Zoning Chart Revision – R3YY[XXXX] Trailsedge Phase 4 Subdivision

**RE: Zoning Chart Revision – Proposed R3YY[XXXX] Zone
Trailsedge Phase 4 Subdivision
Draft Plan of Subdivision & Zoning By-law Amendment (D07-16-21-0006 and D02-02-21-0023)**

Figure 1 Proposed Zoning Map - Trailsedge Phase 4.

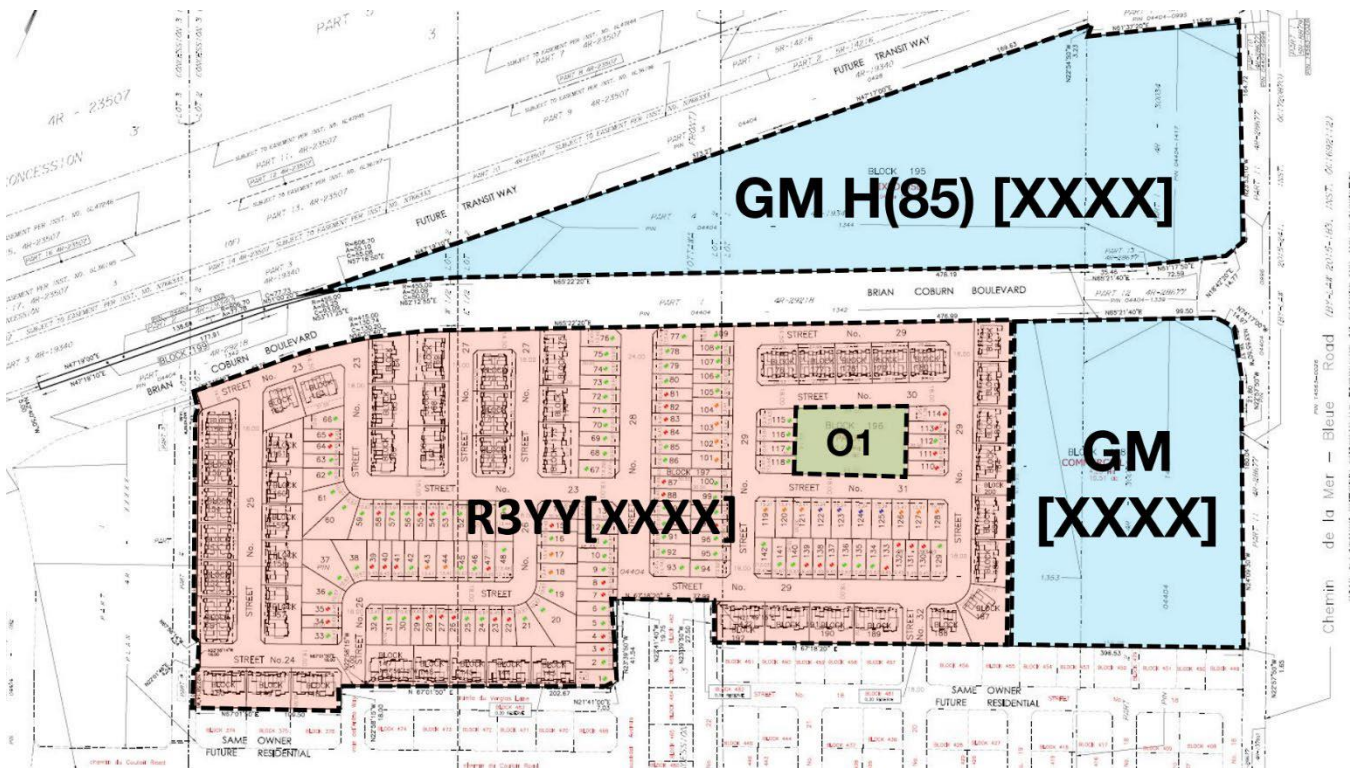
As was indicated in our originally submitted Planning Rationale, dated March 16th, 2021, the “Residential Third Density Zone, Subzone YY, with Exceptions (R3YY[XXXX])” zoning is proposed for the low-rise residential component of the proposed plan of subdivision (Figure 1). Some of the provisions for the back-to-back townhouse product were incorrect in our original Planning Rationale. Therefore, the purpose of this letter is to clarify the proposed provisions for the portion of the subdivision to be zoned R3YY[XXXX].

The proposed Exception would vary the R3YY provisions to allow for a similar built form and density for the area. **More specifically, the Exception would address the following items:**

- / **Three provisions that address the unique characteristics of the back-to-back townhouse dwelling type, including:**
 - o **A smaller minimum lot area (84 m²);**
 - o **A greater minimum interior side yard setback (1.5 m); and**
 - o **The need to have air conditioners in the front or corner side yards given that this dwelling type does not have a rear yard.**

- / **A front yard setback of 4.5 metres for all unit types to achieve an urban built form where the buildings frame the street.**

- / **A corner yard setback of 3 metres for all unit types.**
